Product Change Notice (PCN)

PCN Number: **PCN-0450969R-01**

Product(s) Affected: *SJ1-351X Series. (SJ1-3513, SJ1-3514, SJ1-3515)*

| PREVIOUS CUI DETAIL / IMAGE | | | NEW CUI DEVICES DETAIL / IMAGE | | | | | | | | | | | | | | | | | | | | | | | | | | | | | | | | | | | | | | | | | | | | | | | | | | | | | | | | | | | | | | | | | |

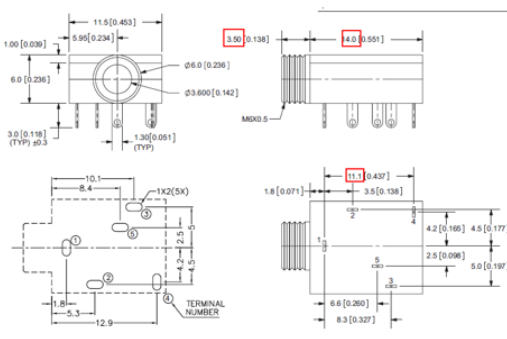
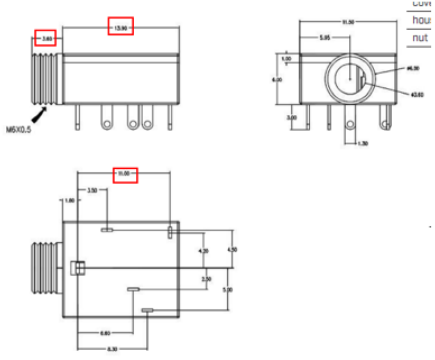
Reason(s) for Change: *Tooling and Material Change*

Description of Change: *Slight Dimensional difference. Terminal Material Change See image Below*

| PREVIOUS CUI DETAIL / IMAGE | | | NEW CUI DEVICES DETAIL / IMAGE | | | | | | | | | | | | | | | | | | | | | | | | | | | | | | | | | | | | | | | | | | | | | | | | | | | | | | | | | | | | | | | | | |
|--|-----------------------|---------------|---|----------|---------|------------|-------|--------|------------|-------|--------|------------|-------|--------|------------|-------|--------|------------|-------|--------|---------|-------|--------|--------|-----------------|--|-------|-----|--|---------|-----|--|---|--|--|-------------|----------|---------------|------------|-------------|--------|------------|-----------------------|--------|------------|-------------|--------|------------|-------------|--------|------------|-----------------------|--------|---------|-------|--------|--------|-------|-------|-------|---------------|-------|---------|---------------|-------|-----|------------|-----|
| DESCRIPTION | MATERIAL | PLATING/COLOR | | | | | | | | | | | | | | | | | | | | | | | | | | | | | | | | | | | | | | | | | | | | | | | | | | | | | | | | | | | | | | | | | | |
| terminal 1 | brass t=0.3 | silver | | | | | | | | | | | | | | | | | | | | | | | | | | | | | | | | | | | | | | | | | | | | | | | | | | | | | | | | | | | | | | | | | | |
| terminal 2 | phosphor bronze t=0.3 | silver | | | | | | | | | | | | | | | | | | | | | | | | | | | | | | | | | | | | | | | | | | | | | | | | | | | | | | | | | | | | | | | | | | |
| terminal 3 | brass t=0.3 | silver | | | | | | | | | | | | | | | | | | | | | | | | | | | | | | | | | | | | | | | | | | | | | | | | | | | | | | | | | | | | | | | | | | |
| terminal 4 | brass t=0.3 | silver | | | | | | | | | | | | | | | | | | | | | | | | | | | | | | | | | | | | | | | | | | | | | | | | | | | | | | | | | | | | | | | | | | |
| terminal 5 | phosphor bronze t=0.3 | silver | | | | | | | | | | | | | | | | | | | | | | | | | | | | | | | | | | | | | | | | | | | | | | | | | | | | | | | | | | | | | | | | | | |
| bushing | brass | nickel | | | | | | | | | | | | | | | | | | | | | | | | | | | | | | | | | | | | | | | | | | | | | | | | | | | | | | | | | | | | | | | | | | |
| spring | steel | black | | | | | | | | | | | | | | | | | | | | | | | | | | | | | | | | | | | | | | | | | | | | | | | | | | | | | | | | | | | | | | | | | | |
| cover | PBT (UL94V-0) | black | | | | | | | | | | | | | | | | | | | | | | | | | | | | | | | | | | | | | | | | | | | | | | | | | | | | | | | | | | | | | | | | | | |
| housing | PBT (UL94V-0) | black | | | | | | | | | | | | | | | | | | | | | | | | | | | | | | | | | | | | | | | | | | | | | | | | | | | | | | | | | | | | | | | | | | |
| nut | zinc alloy | tin | | | | | | | | | | | | | | | | | | | | | | | | | | | | | | | | | | | | | | | | | | | | | | | | | | | | | | | | | | | | | | | | | | |
